AMENDMENTS TO THE DRAWINGS

### REMARKS

Title: Redistribution Layer Shielding of a Circuit Element

App. No. 10/814,816

FIG. 5B

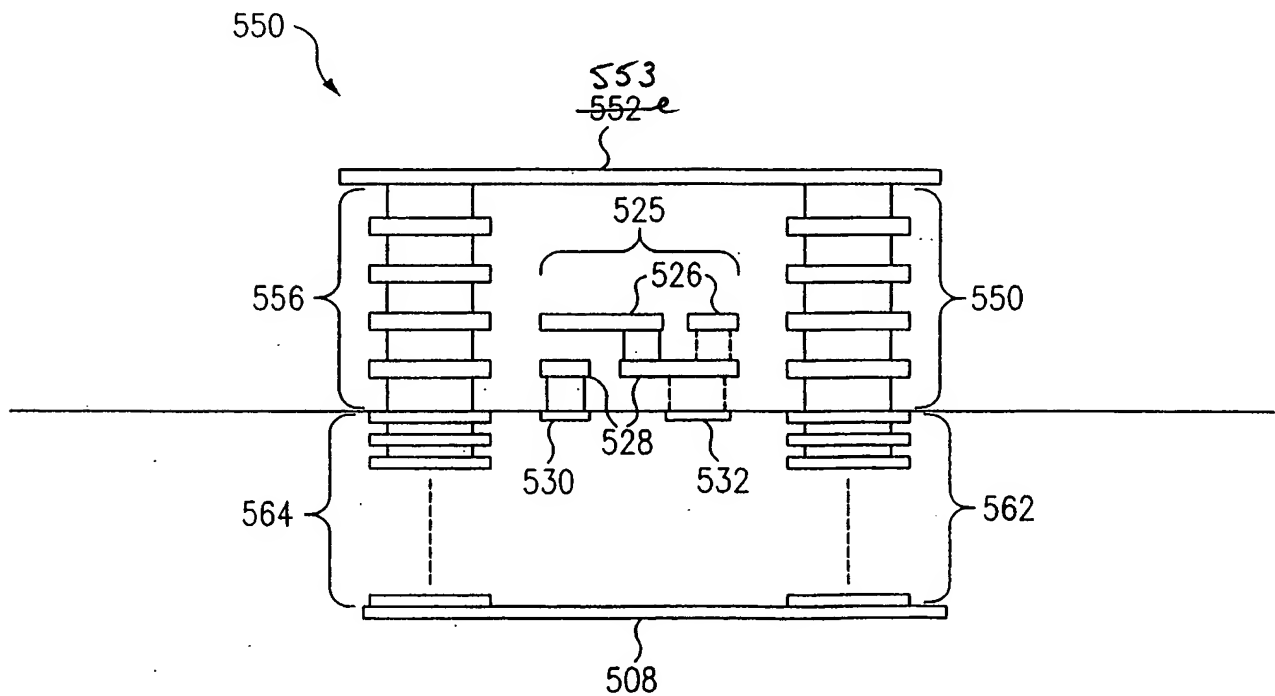
Figure 5B is amended to change the reference numeral of top plate 552 to top plate 553.

The specification is amended to be consistent with the drawings. The specification is amended to change the reference numeral of top plate 552 of FIG. 5B to top plate 553.

FIG. 9A

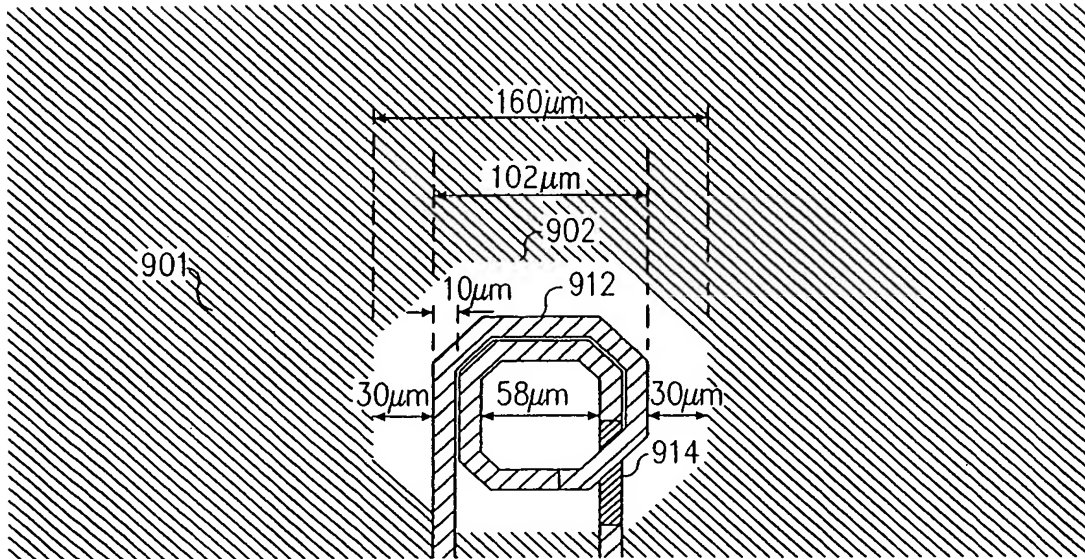
The drawings are objected to as failing to comply with 37 C.F.R. 1.84(p)(5) because they include the following reference characters not mentioned in the description: 1000, 1002, 1004, 1006, 1008, 1010, 1016, and 1066. Figures 9A, 9B, 9C and 10 are amended consistent with the specification.
